**DEVELOPMENT REVIEW COMMITTEE
STAFF REPORT
JANUARY 23, 2024**

Prepared by: Amy Wolfson, City Planner

Application Number: 23PLN-41
Subject: Development Review Permit for the construction of a ±4,300 square foot retail paint store for Sherwin-Williams on a ± 1.5 acre parcel (after pending lot line adjustment) on Nevada City Highway (next to Lumberjacks Restaurant)
Owner: Matt McWhirter (representative)
Applicant: McWhirter Realty Partners
Zoning/General Plan: Central Business (C-2) Zone/Commercial
Entitlements: Development Review Permit

Proposed Sherwin-Williams Paint Store rendering

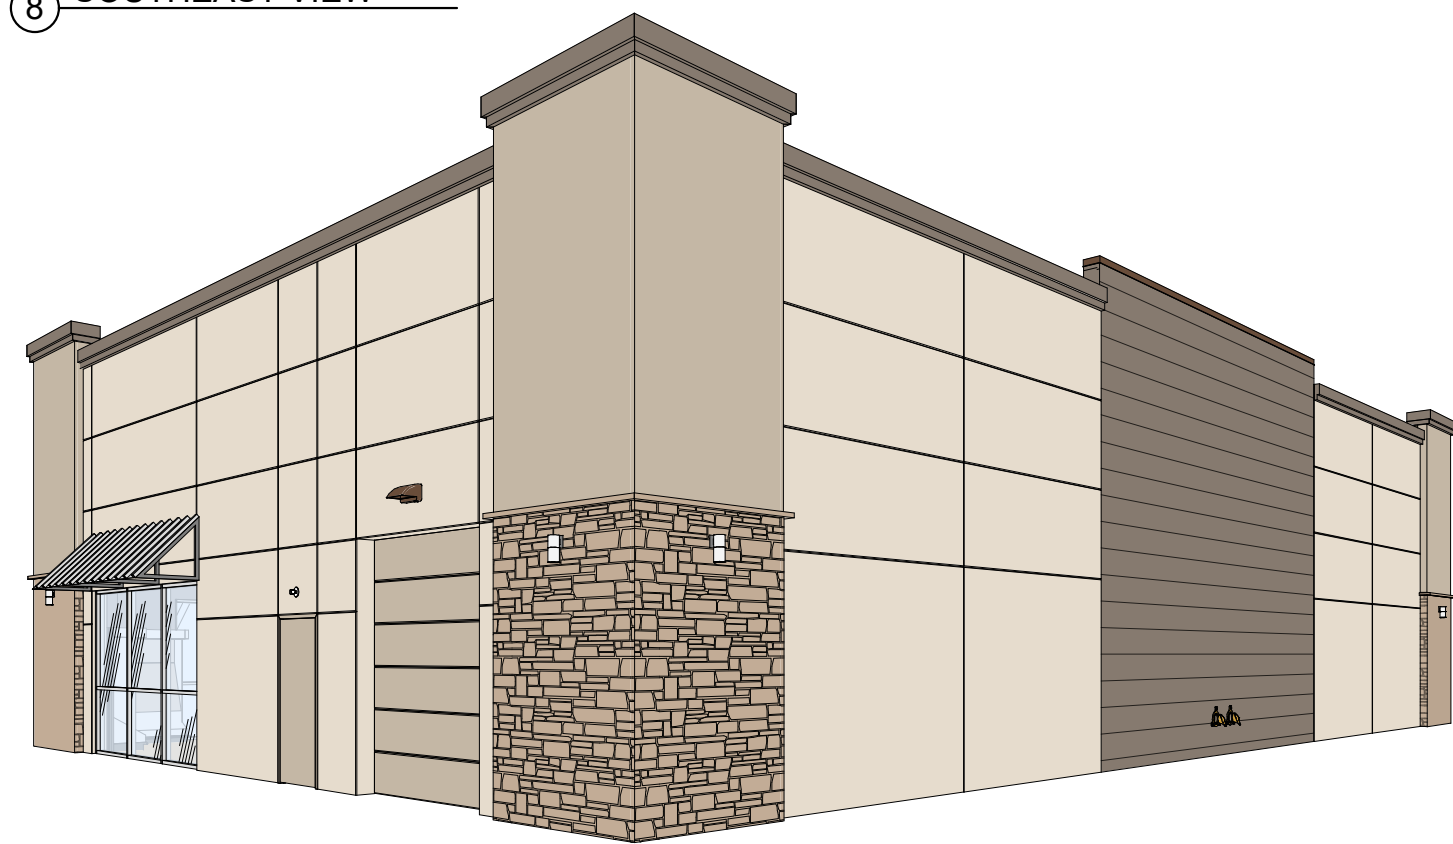
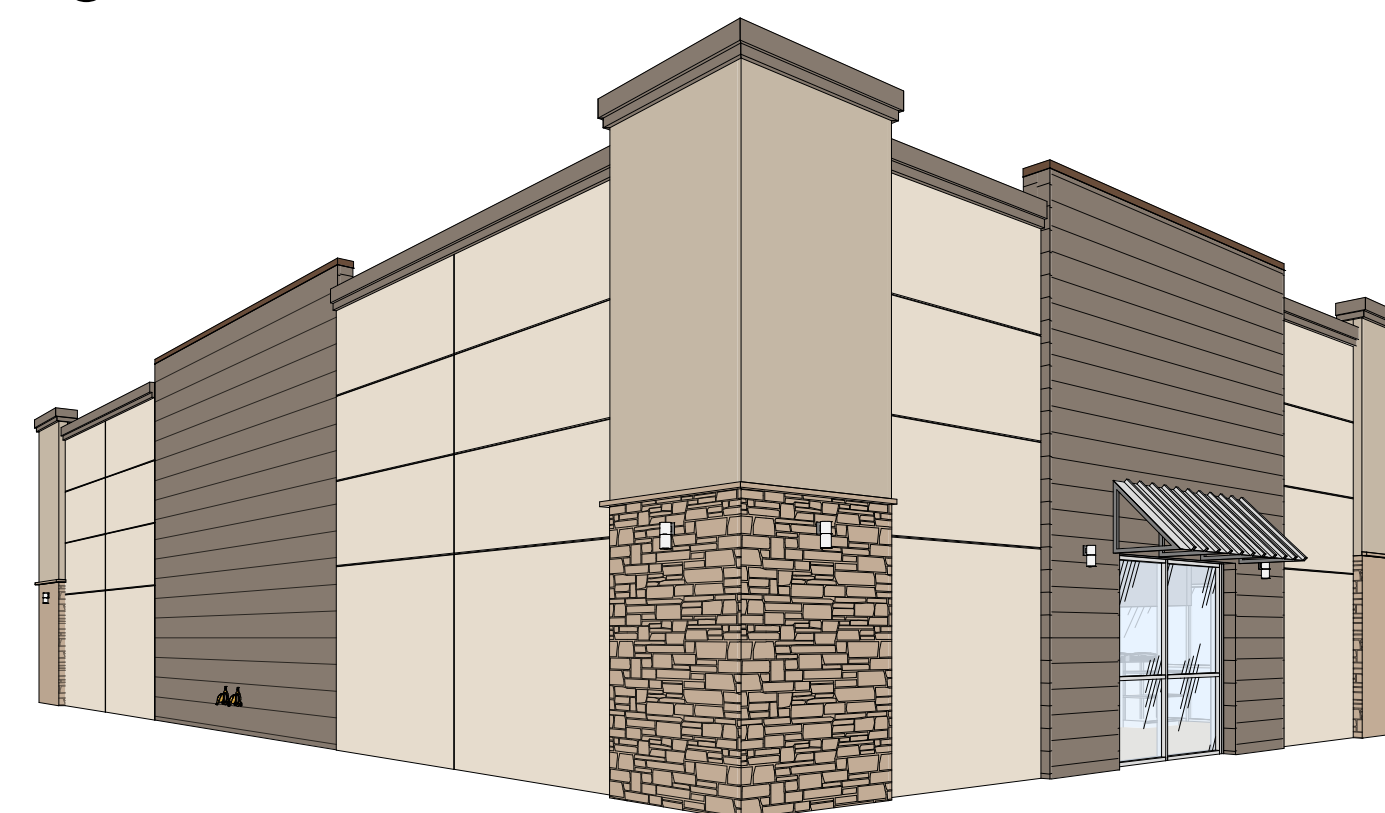
While the updated version of the plans is improved from an initial design, staff still has some concerns about its conformity to the following community design guidelines:

- 2.1 (e): Infill building design shall be consistent with the neighborhood's historical development types in terms of scale, design and materials. *Heavy timber elements, corrugated metal, wood, stone, horizontal lap and board and batten siding, are examples of appropriate materials.*

- 2.3 (d): Roof materials shall be consistent with the existing neighborhood and the quality and style of other building materials used. Appropriate roofing material considerations for use in the Grass Valley area include, but are not limited to, slate, concrete tile (flat with smooth or raked finish), copper, standing seam or batten metal roof (factory applied enamel finishes only), corrugated metal simulated wood shakes or shingles and architectural grade composition shingles. *The roof styles suggested in the guidelines appear to assume a pitched roof-style.*

- 2.4 (a): Construction materials that will replicate a sense of Grass Valley's mining heritage shall be utilized in new construction. These include but are not limited to metal roofing and siding, wood siding, split faced block, and stone. Attention to detail in application is the key in successful material use

4 EAST ELEVATION
1/8" = 1'-0"

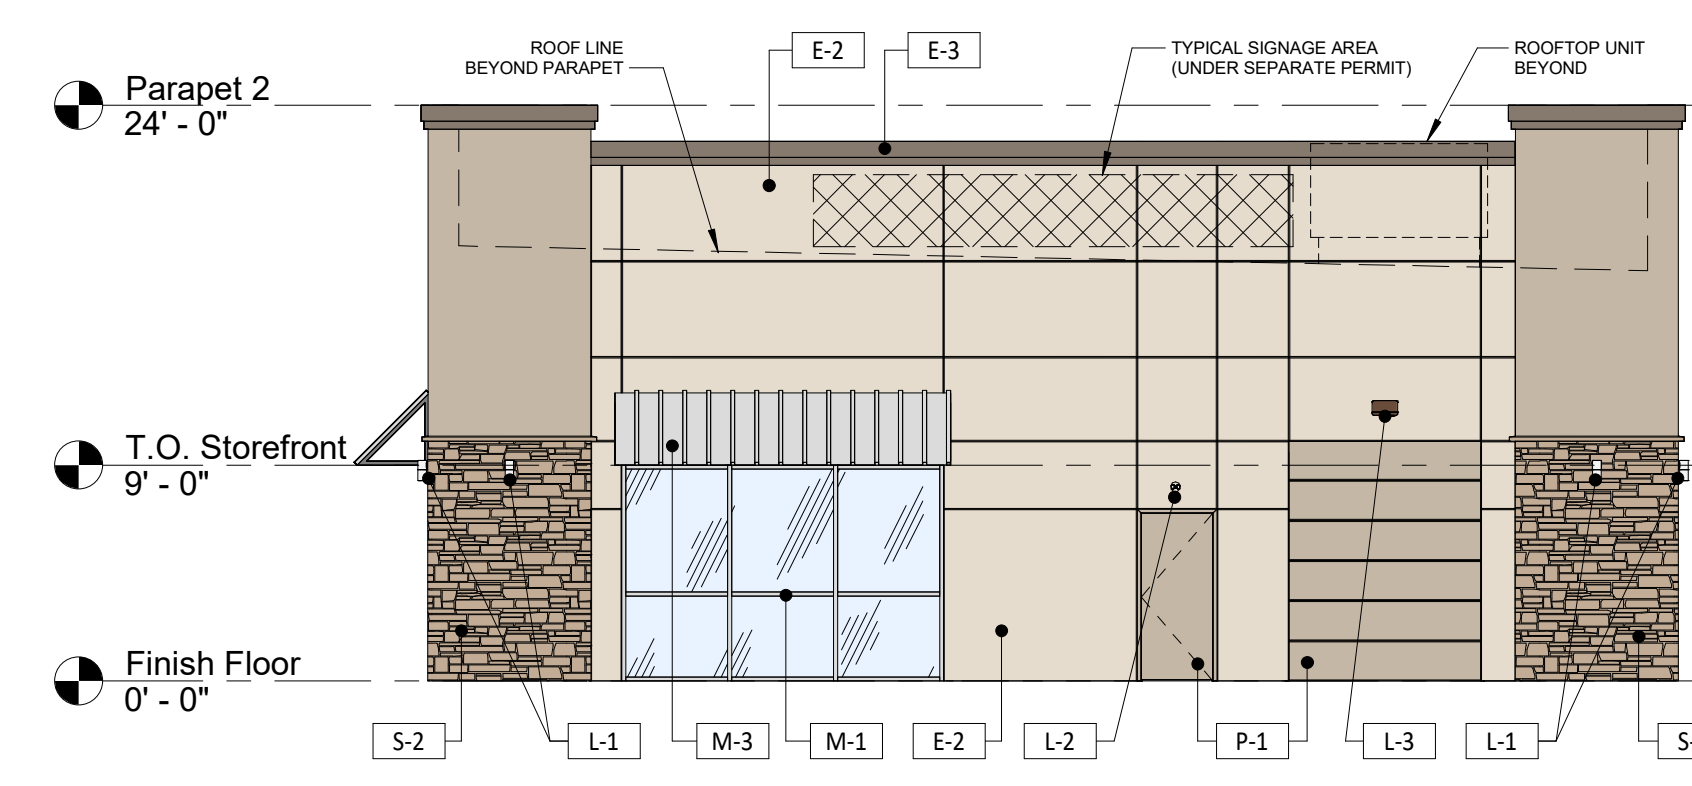
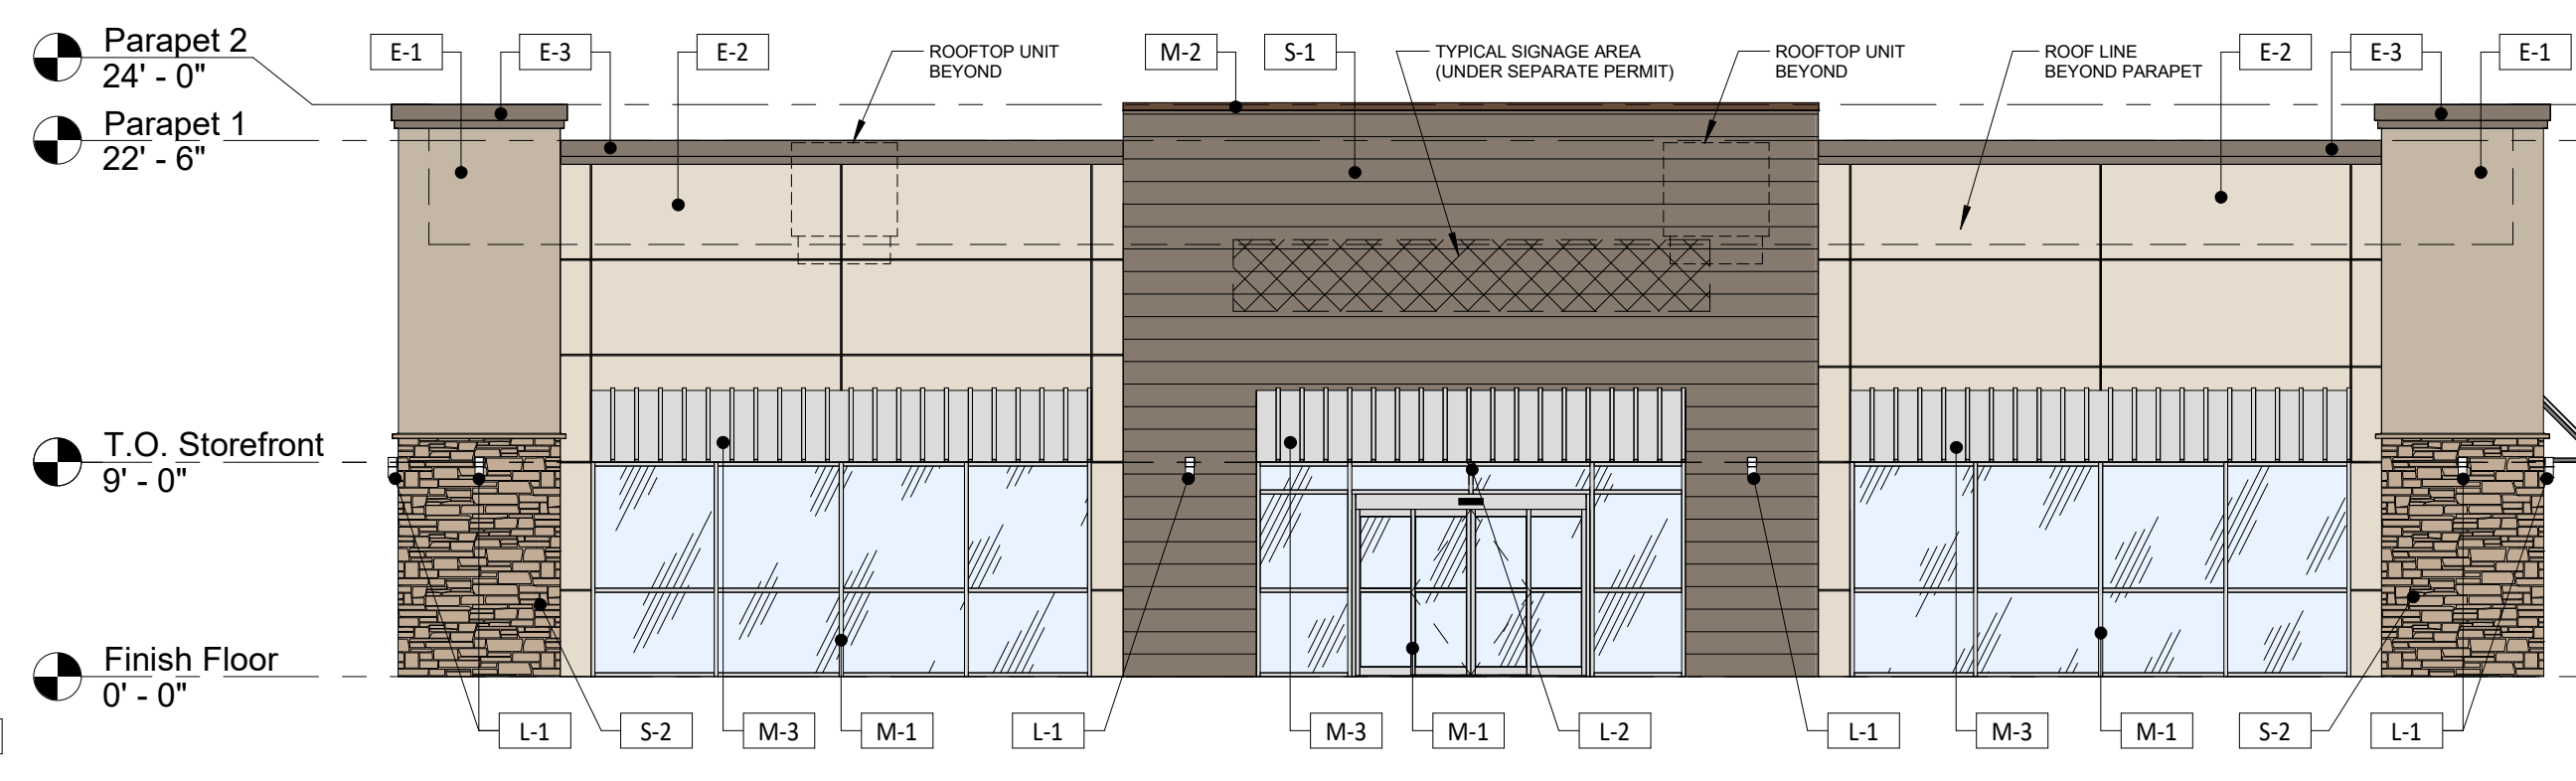
8. The security lighting labeled on the light schedule as “L-2,” and referenced on the east and south elevations will need to be revised to comply with the city’s outdoor lighting standards in section 17.30.060 of the city municipal code.
9. The Lot Line Adjustment shall be amended to ensure each resulting property containing Commercial Business Park zoning contains a minimum of 1.5 acres. The Lot Line Adjustment shall be filed and recorded prior to building permit issuance.
10. The applicant agrees to defend, indemnify, and hold harmless the City of Grass Valley in any action or proceeding brought against the City of Grass Valley to void or annul this discretionary land use approval
